YR-2022/834 - 1 BAYNES PARK ROAD, MONBULK – PLANNING REPORT

Site Address	1 Baynes Park Road, Monbulk (Lot 1 on Plan of Subdivision 119336)
Application No.	YR-2022/834
Proposal	Use of land for a childcare centre, building and works to construct a childcare centre, building and works to construct of a front fence, removal and lopping of vegetation and removal of access to a Transport Zone 2
Existing Use	Residential dwelling
Applicant	Apex Town Planning
Zone	Clause 32.03 - Low Density Residential Zone
Overlays	Clause 42.03 - Significant Landscape Overlay (Schedule 22) Clause 44.06 - Bushfire Management Overlay (Schedule 1)
Permit triggers	Clause 32.03 - Low Density Residential Zone <ul style="list-style-type: none"> Use and Development of the land for a childcare centre Clause 42.03- Significance Landscape Overlay - Schedule 22 <ul style="list-style-type: none"> Removal and lop vegetation To construct a building or construct or carry out works (front fence, site coverage, permeability, and building height over 7.5 metres) Clause 44.06- Bushfire Management Overlay-Schedule 1 <ul style="list-style-type: none"> To construct a building or construct or carry out works – childcare centre

Figure 14 – Street Tree 12a) large yellow circle on boundary

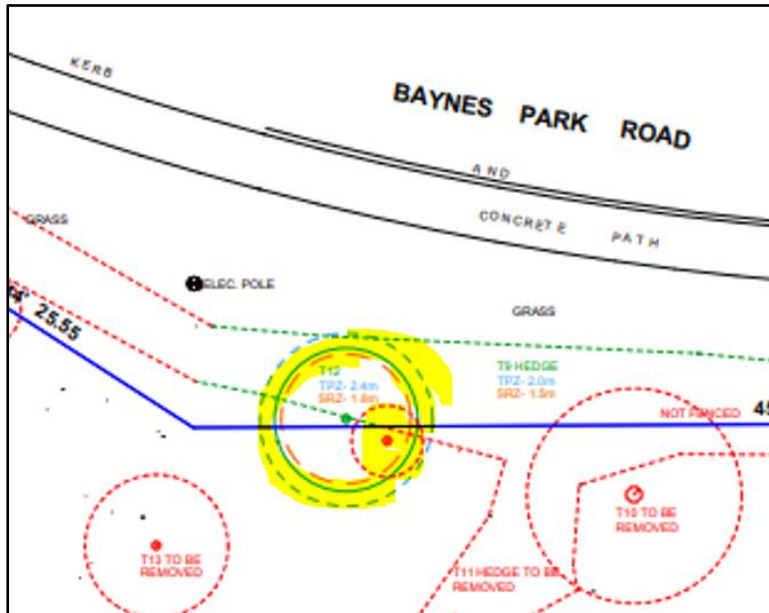
Department	Summary of Response	Planning Officer comment
		addressed between the property owner and Council's arborist. This matter is outside the scope of this planning application and considerations. See image below of tree location figure 14

Figure 15 - Acoustic barriers around the ground floor play areas (Source – Development Plans)

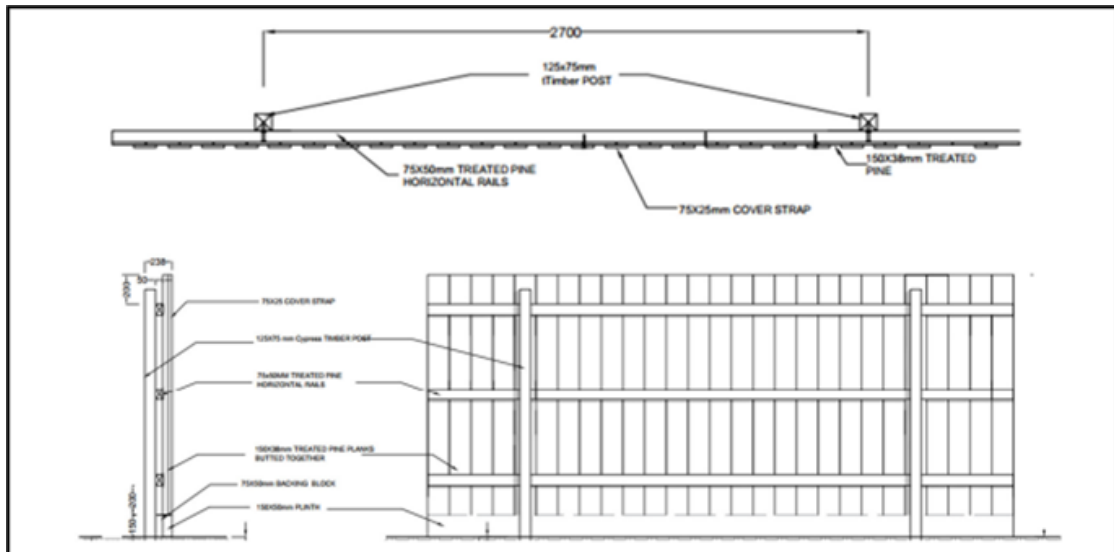
- Acoustic walls/fencing recessed from the south and west title boundaries fences and to be buffered by evergreen landscaping where the setback accommodates via a recommending permit condition. The wall height is not dissimilar to what is ordinarily found in residential areas, for boundary fence or alike (see Figure 15):

Figure 16 – Interior Acoustic measures for Outdoor Play Area 3 – (Source – Development Plans)

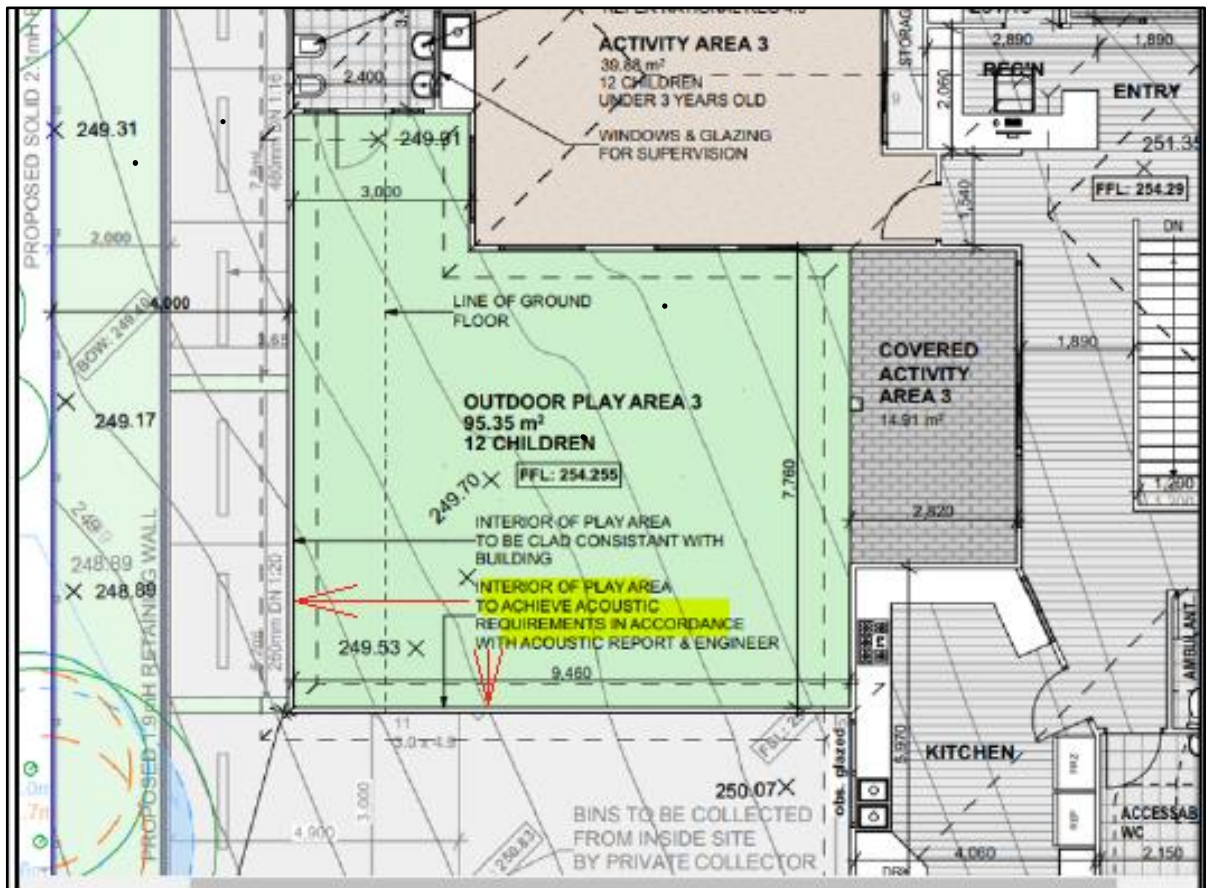
- The first storey (upper level) Outdoor Play Area 3 to have an internal acoustic material behind the wood clad façade which provides both the appropriate acoustic measures as well as keeps the materials consistent with the chosen design characteristic (see Figure 16).

Figure 18 – Negotiated changes between the applicant and adjoining owner (southern elevation)

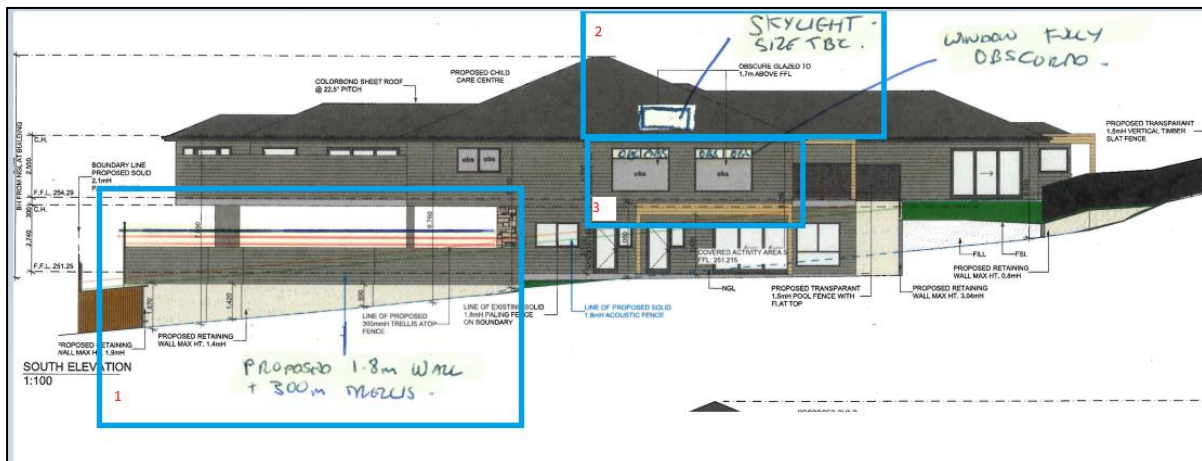
The applicant and southern adjoining property owner and objector initiated their own independent discussions, they have negotiated three voluntary design changes to resolve the objector concerns (shown in Figure 18).

Item	Design change	Officer comment
1.	Installation of 300mm trellis on top of the acoustic fence along the southern end of the carparking area	Acceptable and supported. Recommend a condition placed on any permit granted to secure this agreed change. See Condition 1 (h)
2.	First Floor <i>Activity Area 4</i> southern windows to be obscured	Acceptable and supported. Recommend a condition placed on any permit granted to secure this agreed change. See Condition 1 (i)
3.	Installation of a skylight for <i>Activity Area 4</i> in lieu of item 2.	Acceptable and supported. Recommend a condition placed on any permit granted to secure this agreed change. See Condition 1(j)
